APPLICATION FOR RESOURCE CONSENT OR FAST-TRACK RESOURCE CONSENT

- This is an application to vary the conditions of 2220480-RMAVAR/A pursuant to Section 127 of the Resource Management Act 1991 (RMA) to amend the proposed staging to enable Lot 6 to be created under Stage 1, and the remainder of the lots to be created under Stage 2. Copies of the amended scheme plan (Rev. C) and the approved resource consent decision are **attached** to this letter for your reference.

- 2. The proposed variations are to amend the staging of subdivision thus allowing a reconfiguration of allotments, as depicted on the revised scheme plan attached to this letter (revision C dated 17.11.23).

С	17.11.23	STAGING & LOT6/5 BOUNDARY AMENDMENTS - RS/CC
В	27.01.23	EASEMENT AMENDMENTS - LL/CC
Α	23.12.22	FIRST ISSUE - RS/TM
REV	DATE	DESCRIPTION
REF. [DATA:

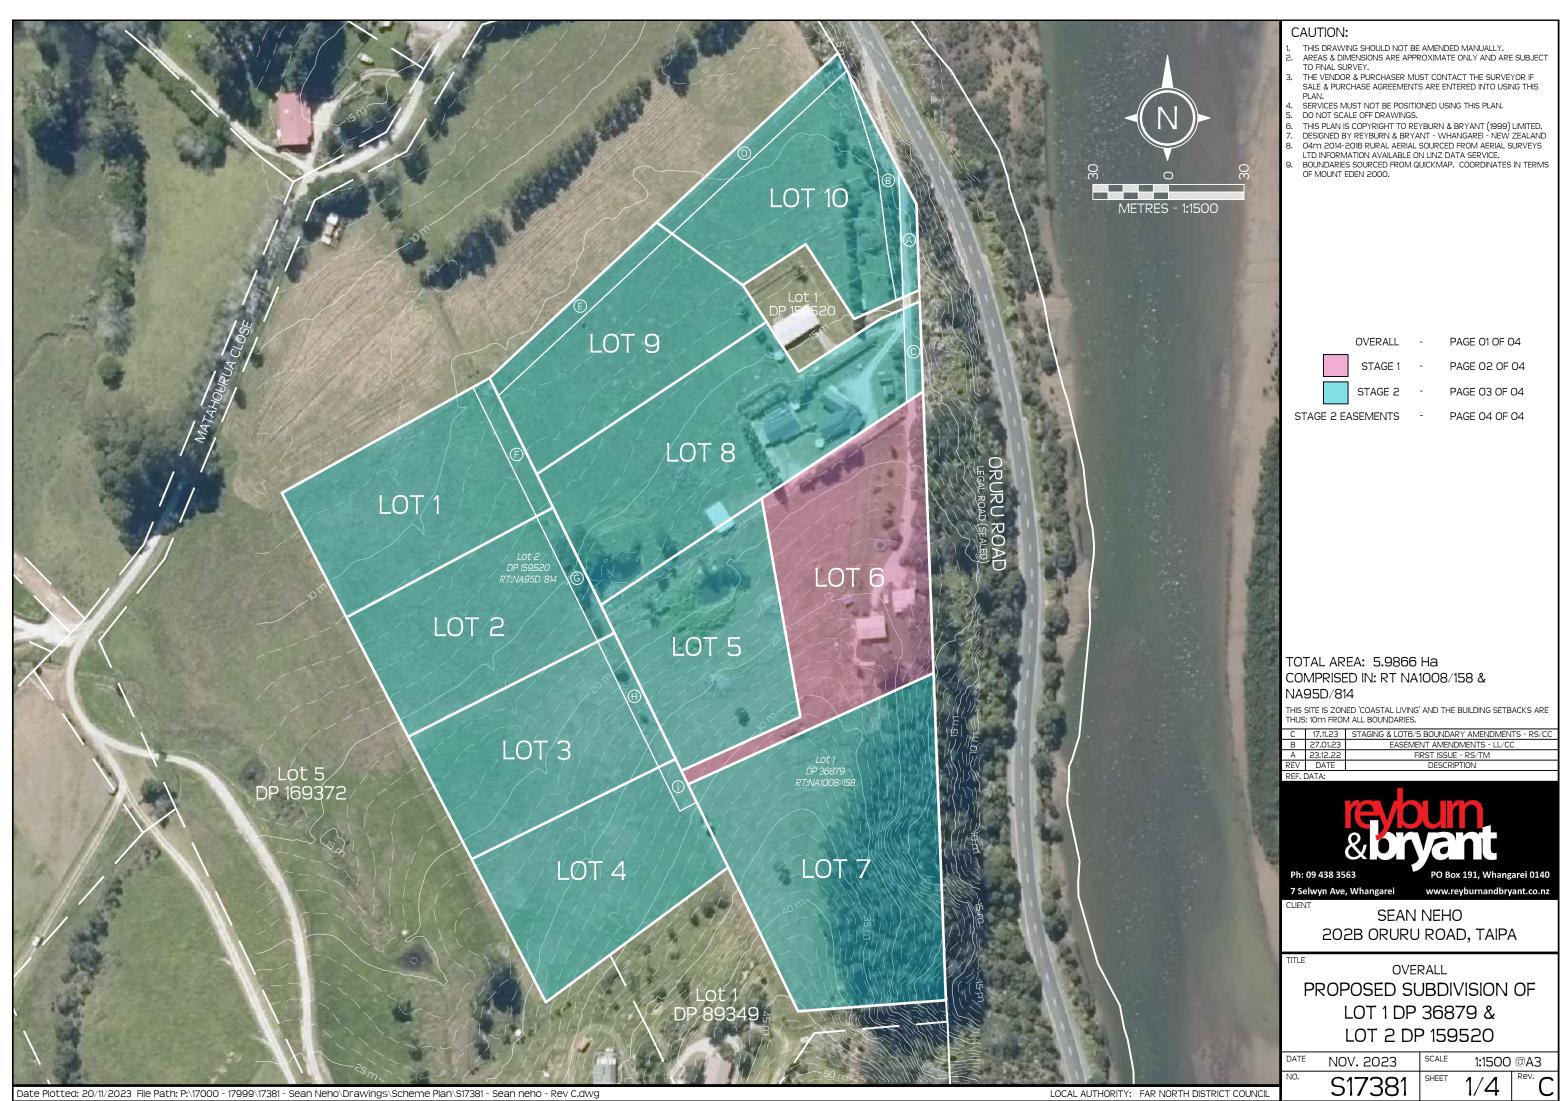
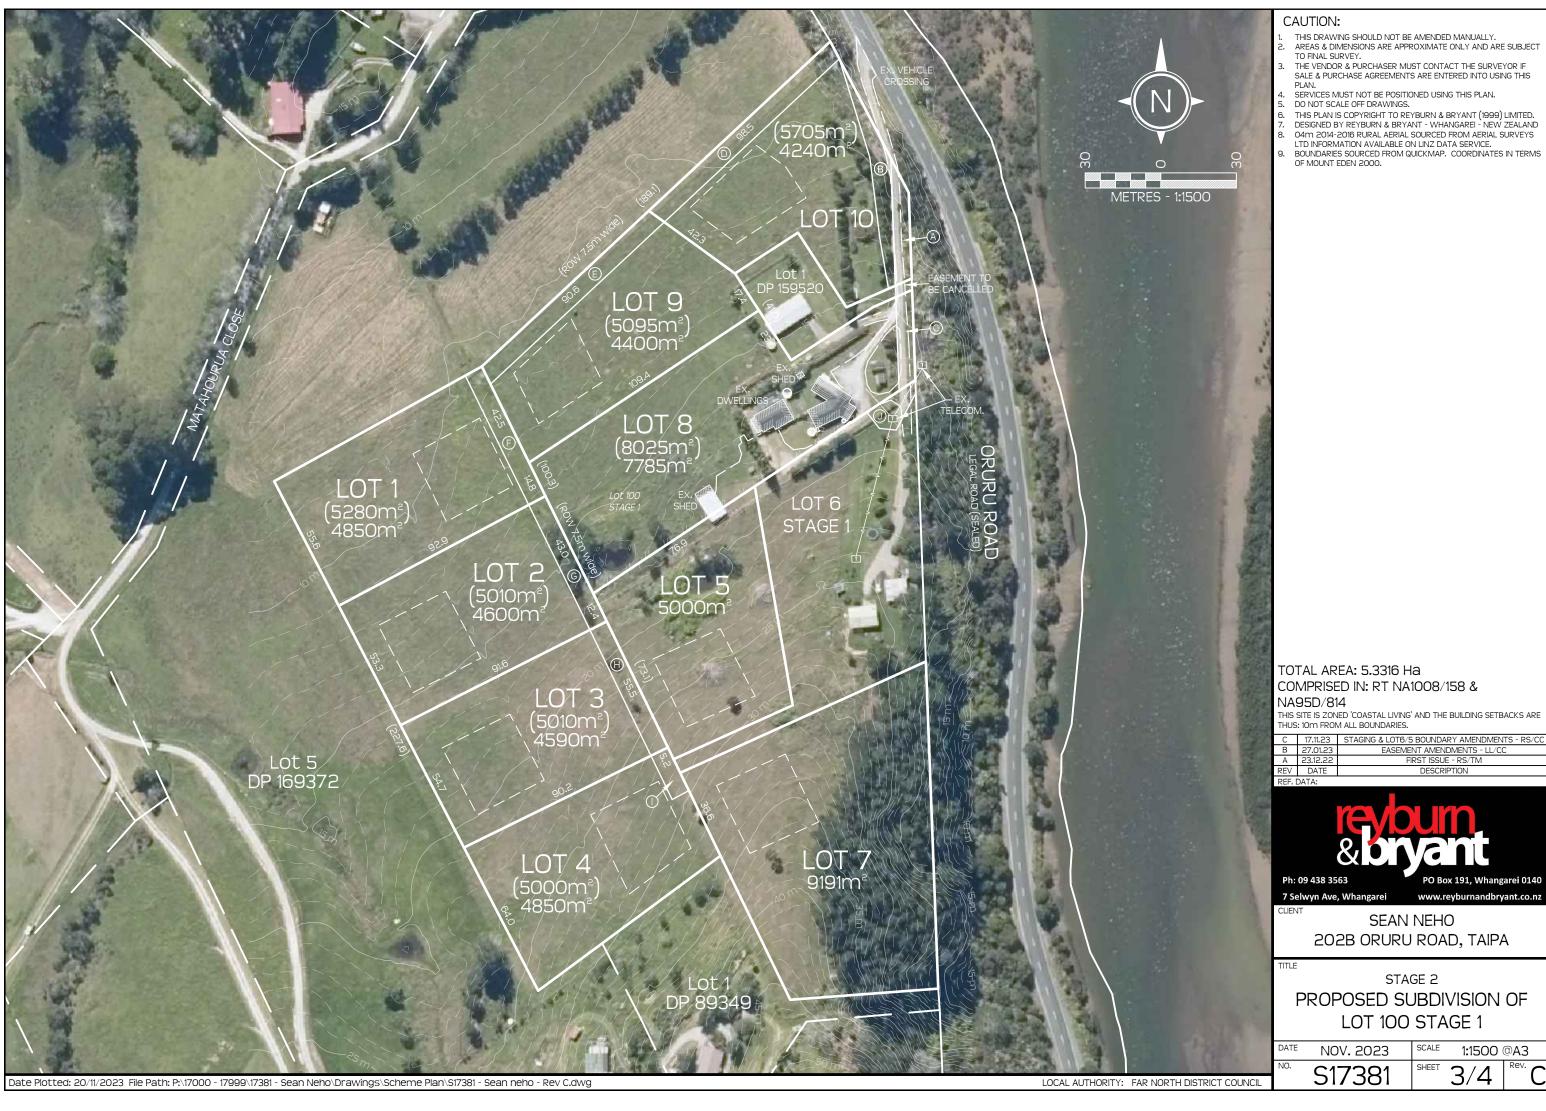
- Stage 1 (Lots 6 and 100); and
 - Stage 2 (Lots 1-4, 5, 7-10).
- 5. For completeness, the scheme plan now shows all relevant easements to be carried through onto the survey plan submitted to Council for s223 certification.

- *1. The subdivision shall be carried out in accordance with the approved plan of subdivision prepared by Reyburn and Bryant Ltd, referenced No S17381 Rev.C, dated 17.11.23 and attached to this consent with the Council's "Approved Stamp" affixed to it.*
- 2. The survey plan, submitted for approval pursuant to Section 223 of the Act shall show:

(b) Building platforms on each undeveloped allotment as outlined on the revised scheme plan Rev C dated 17.11.23.
